Plan Commission Meeting Agenda

TOWER DRIVE CONDOMINIUMS PHASE 1
SECTION 14, TOWNSHIP 10N, RANGE 12E

Ruekert & Mielke, Inc. has completed our review of the site plan for the above referenced project, with an application date of July 15, 2026. The submittal was reviewed in accordance with Columbus Ordinance Chapter 90 - Subdivision and Chapter 114 - Zoning, Chapter 47 - Erosion Control and Chapter 48 - Storm Water Management. This review does not constitute a recommendation for future phases. Future phases for development on this lot shall require additional review and approval. This review may not include all City requirements for this submittal. We offer the following comments, clarifications, or concerns:

PLANTING PLAN

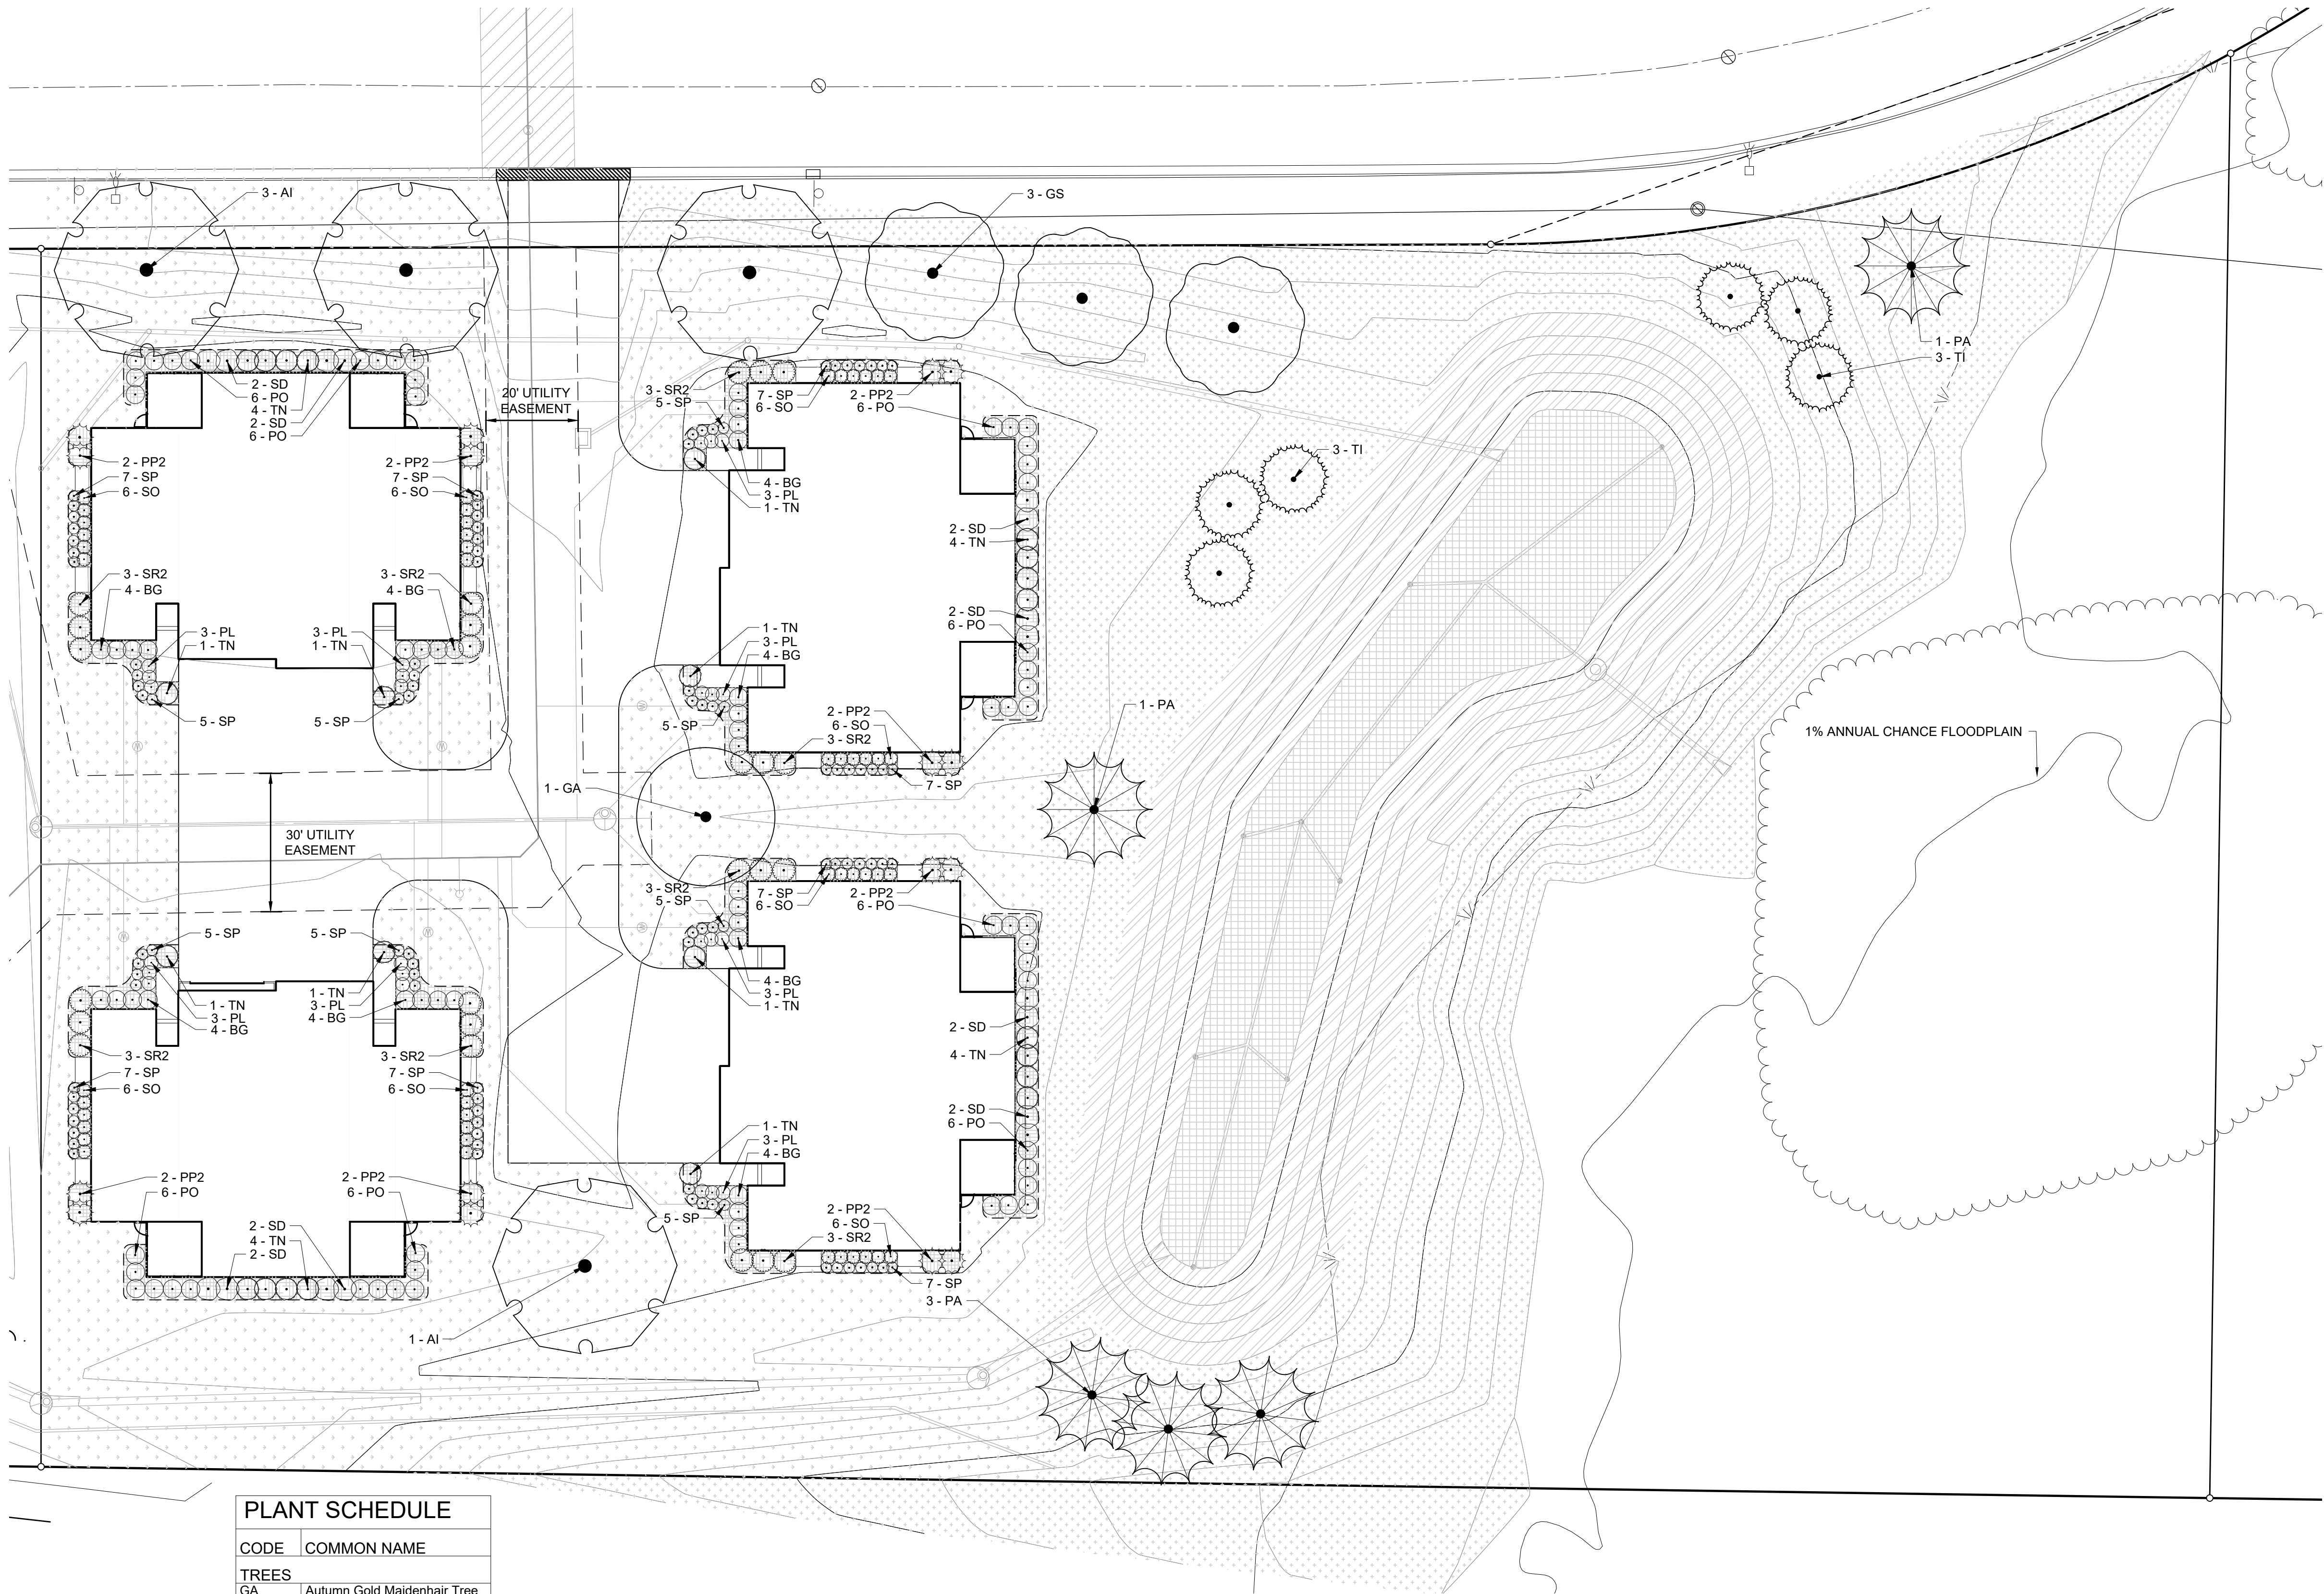
1. Update plan to remove seeding across property line.
